Source: SA WG3
Title: 1 Corrective CR to TS 33.102: Re-transmission of authentication request using the same quintet
Document for: Approval
Agenda Item: 7.3.3

Spec	CR	Rev	Phase	Subject	Cat	Ver	WG	Meeting	S3 doc
33.102	104	1	R99	Re-transmission of authentication request using the same quintet	F	3.5.0	S3	S3-15	S3-000578

Subject: Re-transmission of authentication request using the same quintet

Figure 9: User authentication function in the USIM

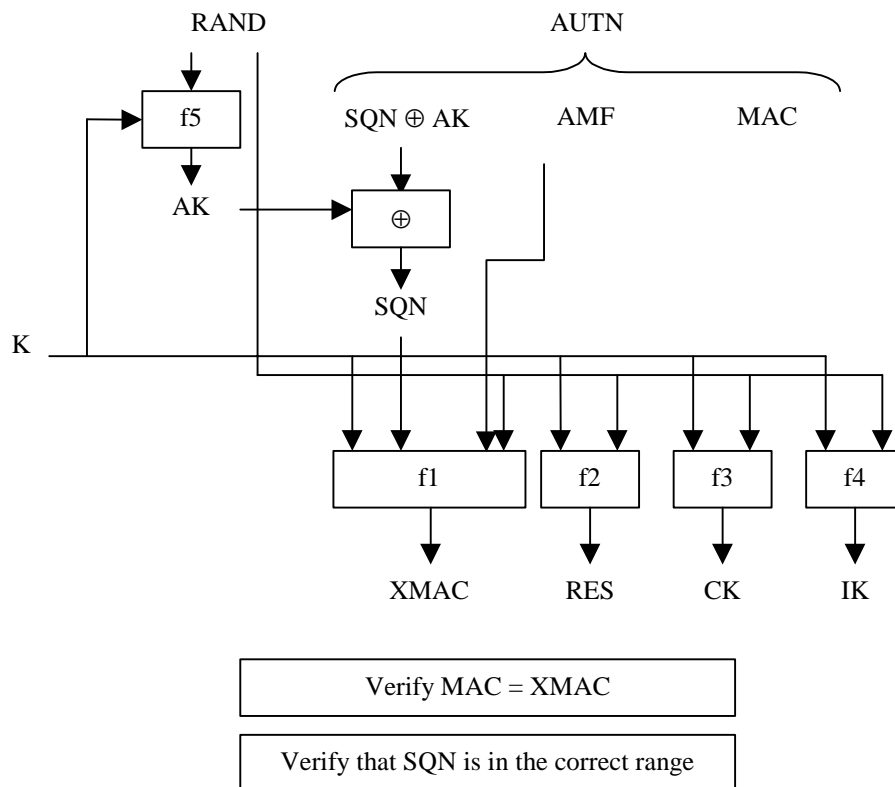
If the sequence number is considered to be in the correct range however, the USIM computes $RES = f2_K (RAND)$ and includes this parameter in a *user authentication response* back to the VLR/SGSN. Finally the USIM computes the cipher key $CK = f3_K (RAND)$ and the integrity key $IK = f4_K (RAND)$. Note that if this is more efficient, RES, CK and IK could also be computed earlier at any time after receiving RAND. If the USIM also supports conversion function c3, it shall derive the GSM cipher key Kc from the UMTS cipher/integrity keys CK and IK. UMTS keys are sent to the MS along with the derived GSM key for UMTS-GSM interoperability purposes. USIM shall store original CK, IK until the next successful execution of AKA.

Conditions on the use of authentication information by the VLR/SGSN: The VLR/SGSN shall use a UMTS authentication vector (i.e. a quintuplet) only once and, hence, shall send out each user authentication request *RAND // AUTN* only once no matter whether the authentication attempt was successful or not. A consequence is that UMTS authentication vectors (quintuplets) cannot be reused.

Re-use and re-transmission of (RAND, AUTN)

The verification of the SQN by the USIM will cause the MS to reject an attempt by the VLR/SGSN to re-use a quintet

to establish a particular UMTS security context more than once. In general therefore the VLR/SGSN shall use a quintet only once.

There is one exception however: in the event that the VLR/SGSN has sent out an *authentication request* using a particular quintet and does not receive a response message (*authentication response* or *authentication reject*) from the MS, it may re-transmit the *authentication request* using the same quintet. However, as soon as a response message arrives no further re-transmissions are allowed. If after the initial transmission or after a series of re-transmissions no response arrives, retransmissions may be abandoned. If retransmissions are abandoned then the VLR/SGSN shall delete the quintet.

At the MS side, in order to allow this re-transmission without causing additional re-synchronisation procedures, the USIM shall store the last (RAND, AUTN) pair as well as the corresponding RES. When the USIM receives an *authentication request* and discovers that a (RAND, AUTN) pair is repeated and the associated START parameter is 0, it shall re-transmit the response. The USIM shall delete the stored (RAND, AUTN) pair and the corresponding RES as soon as the START parameter is updated by the ME (see section 6.4.8).
